From: Richard Bennett <RBennett2@swindon.gov.uk>
Sent: 28 February 2023 15:49
To: Edward Snook <ESnook@swindon.gov.uk>
Cc: LLFA <LLFA@swindon.gov.uk>
Subject: S/COND/22/0711 updated comments

S/COND/22/0711
Condition 40
Whilst we agree with the principles proposed, a further detailed plan for each area is required highlighting exact work required. Points 5-8 must be carried out before any development in the South Marston area commence.

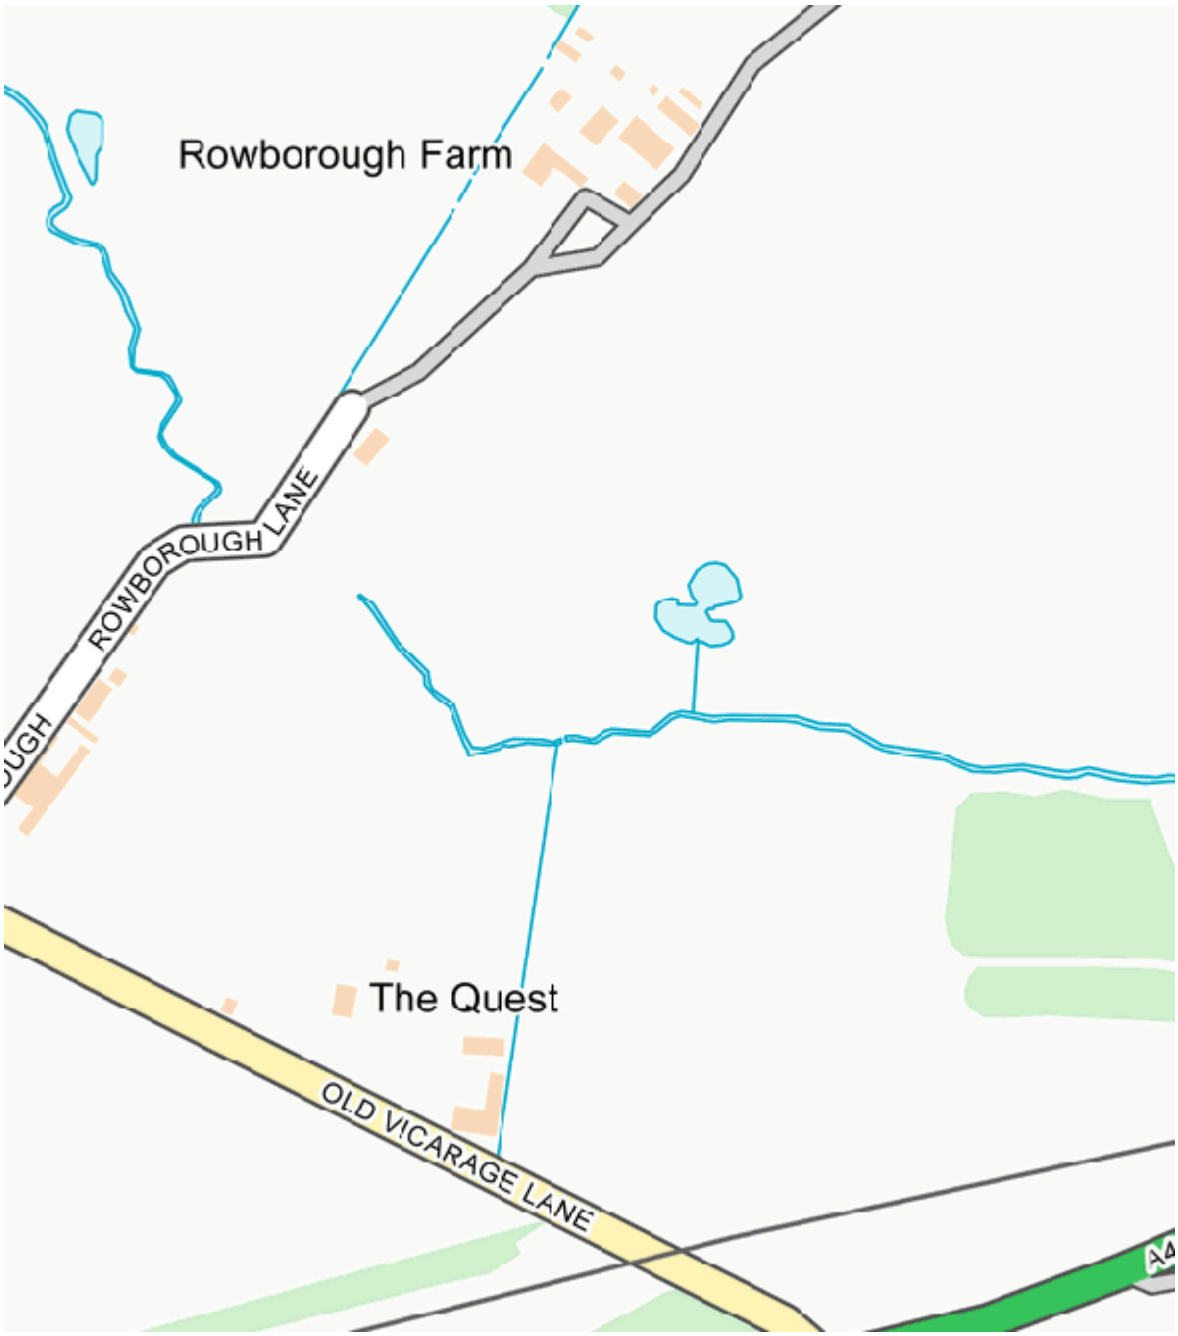
There are issues with existing ponds being affect by proposed Basin B and also a conveyance swale discharging into Basin C although this swale is indicative at this stage. These are shown in the snapshot below.

We will need further details on these ponds (current use, any incoming drainage, current water level etc..).
